Amendments to the Drawings:

Application No. 10/707,590
Amendment dated 12/07/2004
Reply to Office Action mailed 11/09/2004
Annotated Sheet Showing Changes

FIG. 3

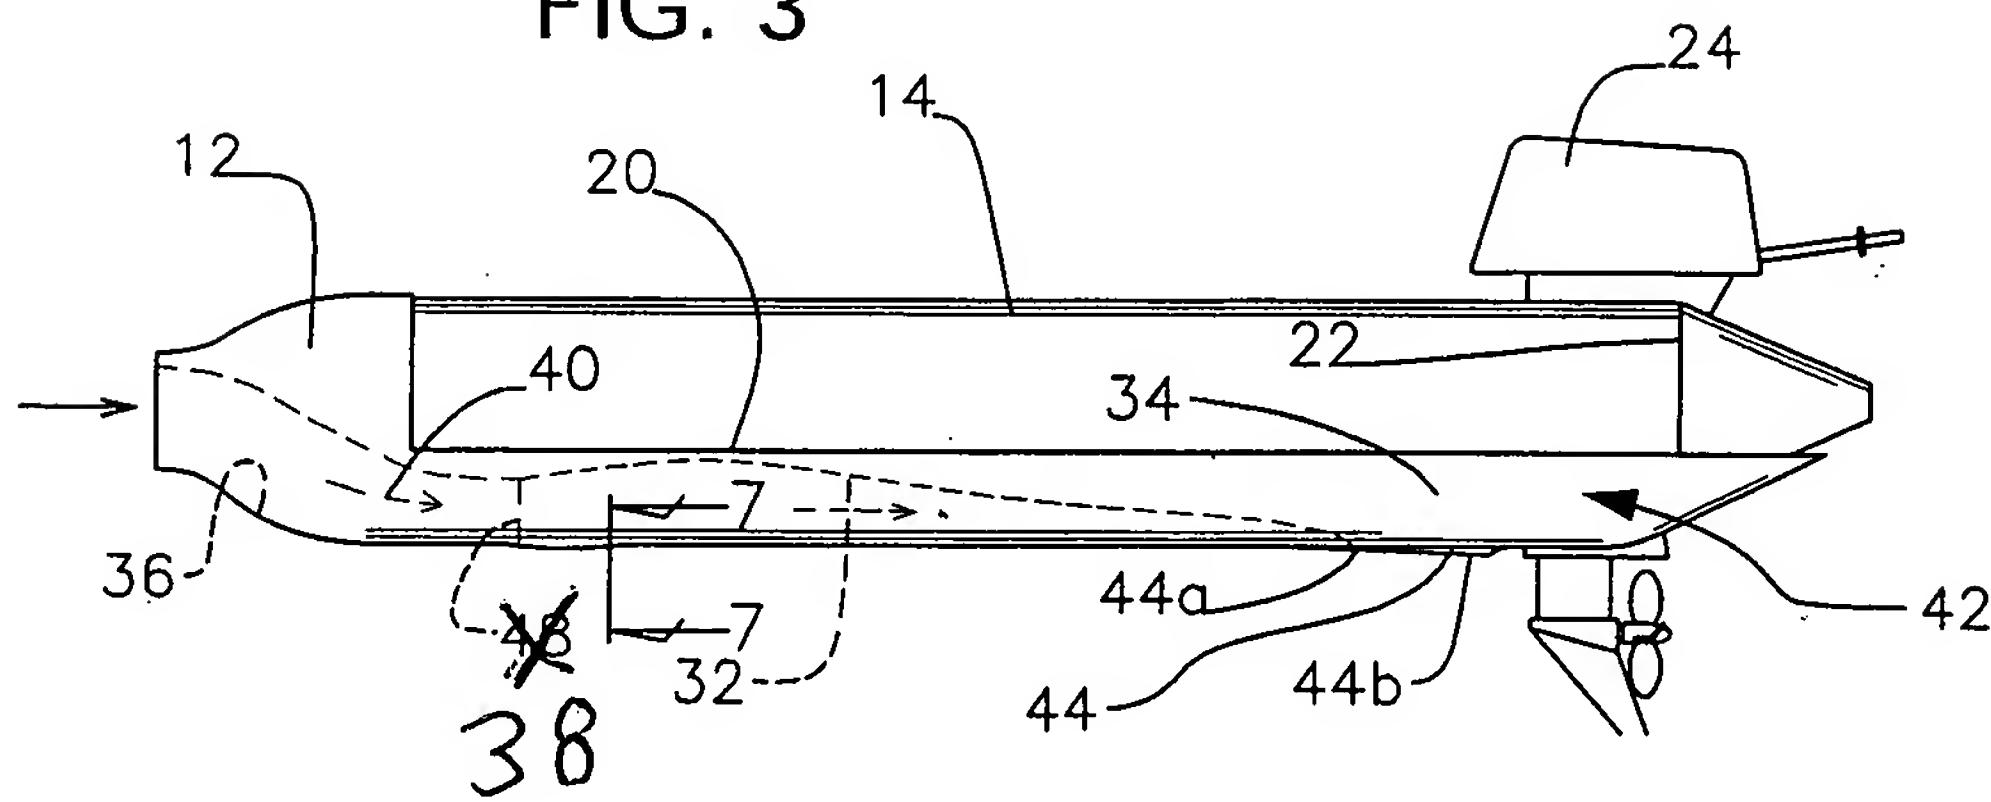
3. The specification stands objected to because paragraphs [0089] and [0090] refer to reference numeral 38 but said reference numeral does not appear in the drawings. A corrected Fig. 3 is filed herewith to bring said Fig. 3 into conformity with said paragraphs. The reference numeral 48 in Fig. 12 is correct because said reference numeral indicates a one-way valve which is positioned in restriction 38. A minor typographical error in paragraph [0097] is also corrected.
